# Limitation description

## Interruption during of the ADC regular conversion – incorrect behavior (G4 Rev Y)

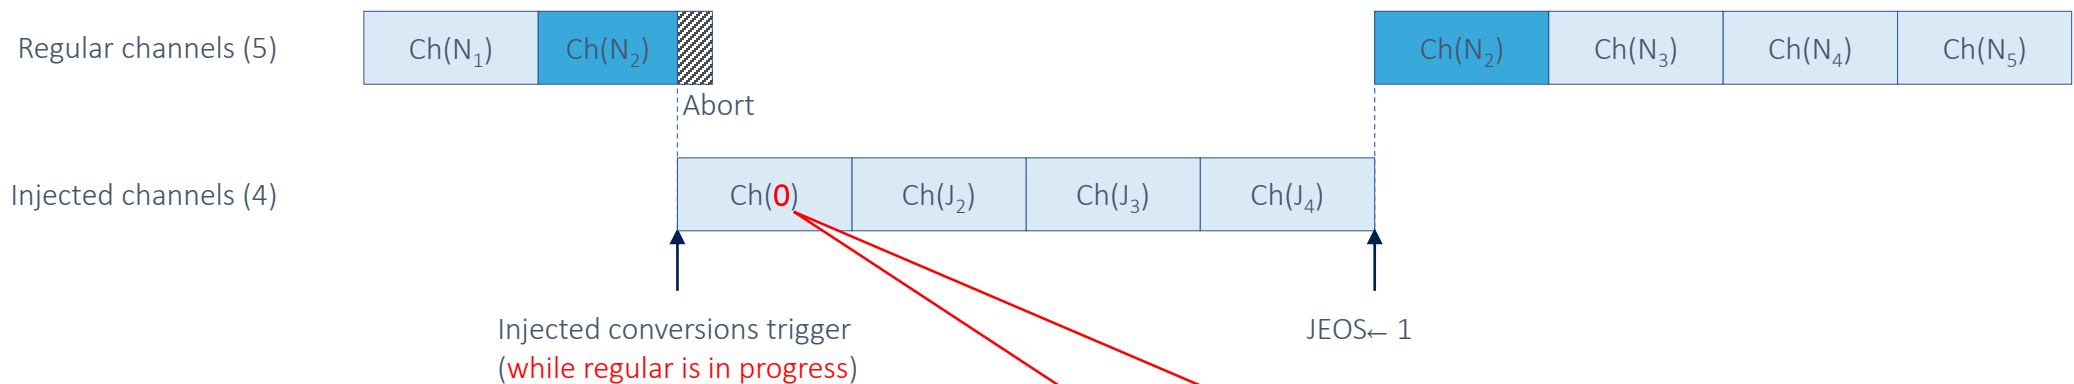
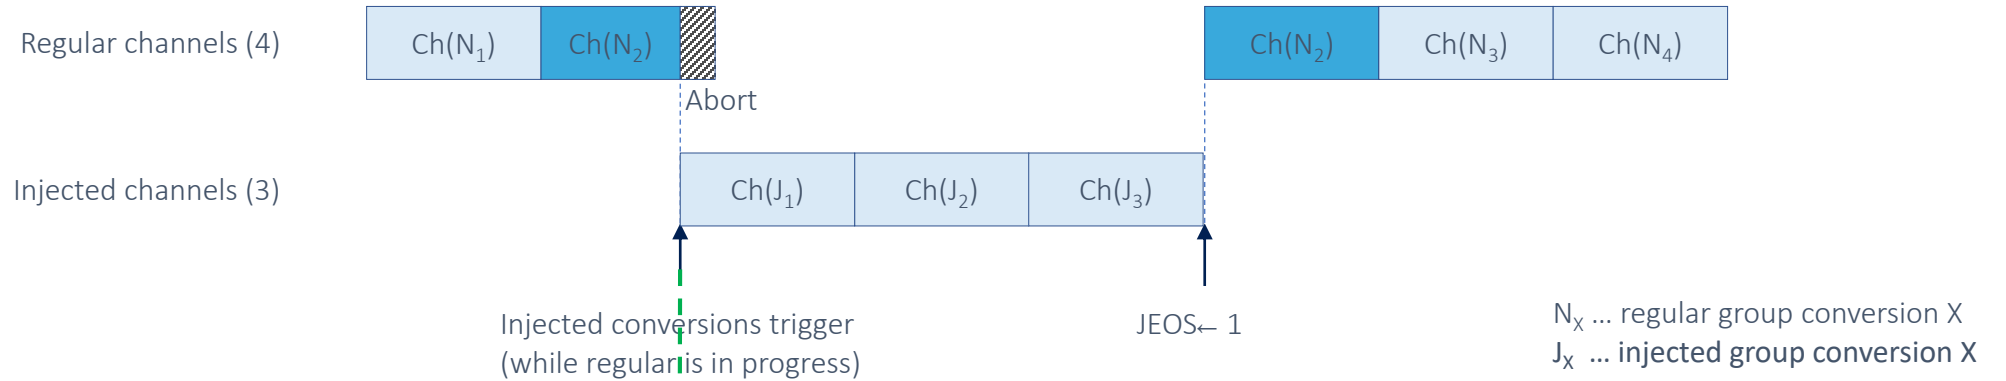
First injected group conversion is replaced by internal **Channel 0** (which is internally grounded).
